DEPARTMENT OF ENERGY

[Case No. BLR-006]

Notice of Petition for Waiver From Johnston Boiler Company From the Department of Energy Commercial Packaged Boiler Test Procedure

ACTION: Notice of petition for waiver and request for public comments.

ATTACHMENT B

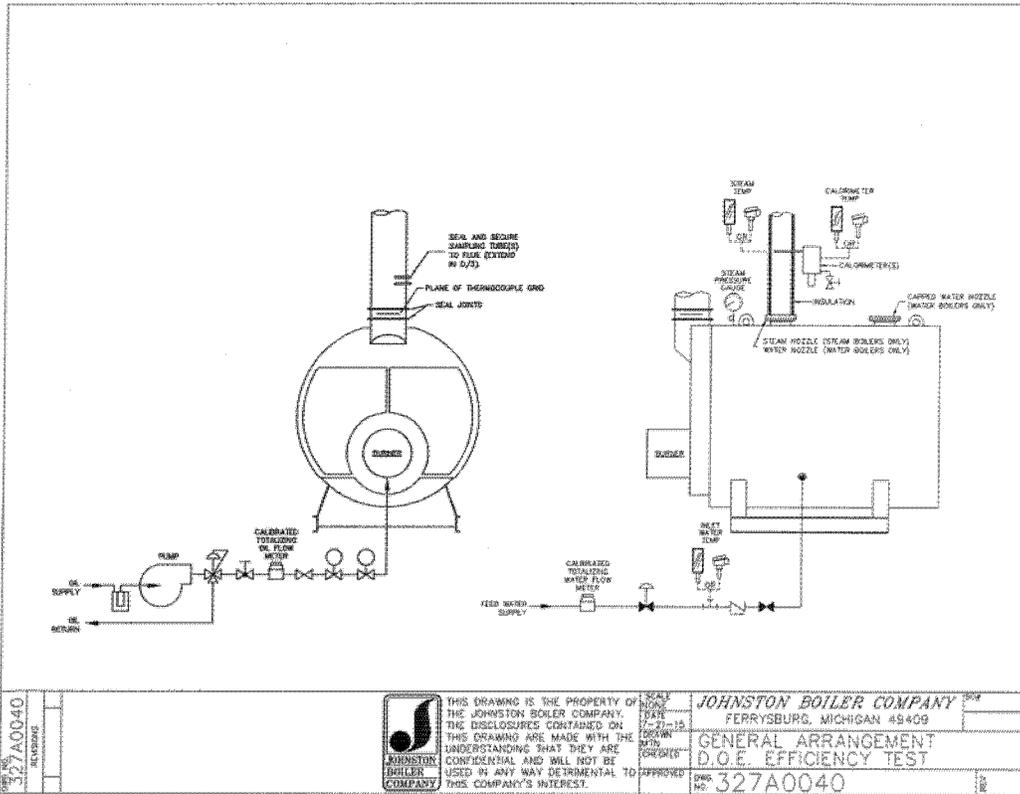
Johnston also requests to use the vertical stack arrangement shown on their "Drawing #327A0040 Johnston Boiler General Arrangement D.O.E. Efficiency Test (attachment B)." DOE's existing test procedure incorporates section 7.0 "Apparatus" of BTS-2000 with respect to test setup including flue connection requirements. (DOE notes that the term "flue," not "stack," is used throughout its test procedure regulations as well as BTS-2000). The flue requirements differ depending on the characteristics of the commercial packaged boiler, including:

diameter results in relatively high velocities and therefore creates turbulence. Johnston indicates that this straight stack arrangement is shown in their operating manual and in the American Boiler Manufacturer Association's (ABMA) "Packaged Boiler Engineering Manual." DOE requests comment on how turbulence affects measured efficiency under the current test procedure, and how use of the vertical stack arrangement shown in the drawing provided by Johnston would prevent turbulence.

4. We will use the vertical stack arrangement shown on our Drawing #327A0040 Johnston Boiler General Arrangement D.O.E. Efficiency Test (attachment B). The large volume of our flue gas in relation to the flue diameter results in relatively high velocities with resulting turbulence. This straight stack arrangement is shown in our operating manual and ABMA's "Packaged Boiler Engineering Manual".
